# CERTIFICATE OF APPROPRIATENESS PLACARD

GLENWOOD FIRE STATION

## Raleigh Historic Development Commission – Certificate of Appropriateness (COA) Application

GLENWOOD FIRE STATION (ENGINE COMPANY NUMBER 4)  
505 JEFFERSON ST., RALEIGH NC  
MINOR WORKS COA APPLICATION

North elevation showing location of proposed electrical outlet on front porch

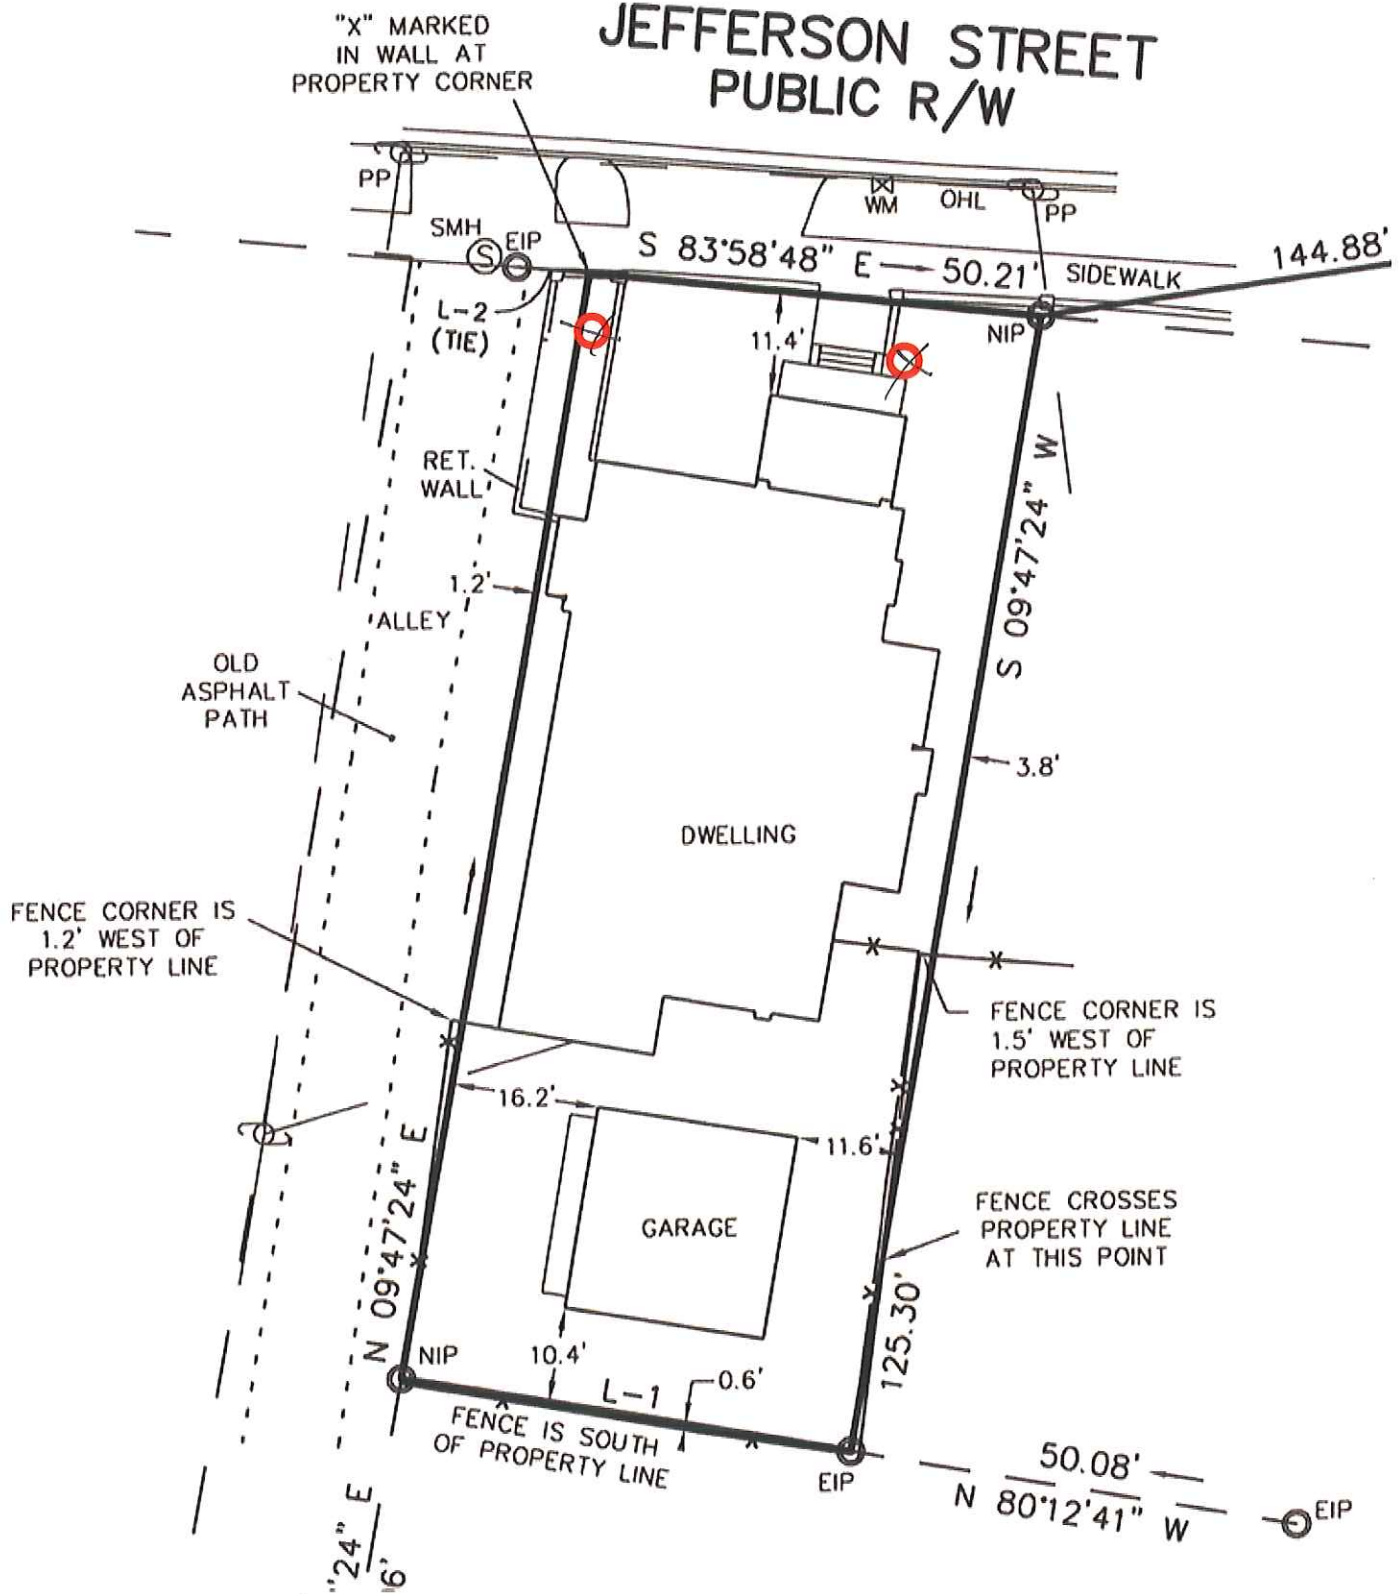
- Per the electrical inspector with the City of Raleigh, the 2014 Electrical Code requires an outlet at every porch or stoop larger than 16 sq. ft. As the porch at 505 Jefferson St. is approximately 115 sf, we are required to install an electrical outlet. The proposed location is under the east window on the entry elevation. The outlet will have a weatherproof outlet cover painted a brick red to match the existing brick to minimize its appearance. Please see the attached photo and outlet cover specification for more information. *will protrude from wall. See email.*

That does help, thank you Tania. I spoke with the GC about the electrical outlet on the front porch at 505 Jefferson. He indicated that we could either surface mount the outlet or cut the brick and recess. Do you recommend the surface mounting?

- Please send in pictures of the house with all windows that will receive exterior storm windows indicated (circled or otherwise).
- For the storm windows confirm that the meeting rail will be in the same location as the meeting rail of the historic window behind.
- In terms of the electrical outlet, can you please clarify how this will impact the brick? A closer photo of the location may help. Will one brick be removed? Two? Will there need to be fill around it?
- The uplighting proposed does not clearly meet the Guidelines and is not approvable by staff.

I do recommend surface mounted The less damage to the historic brick the better. ☺

It is my understanding that the outlet will sit on the face of the brick and no bricks will actually be removed. The wiring will be through the mortar joint. I will clarify this with the GC.
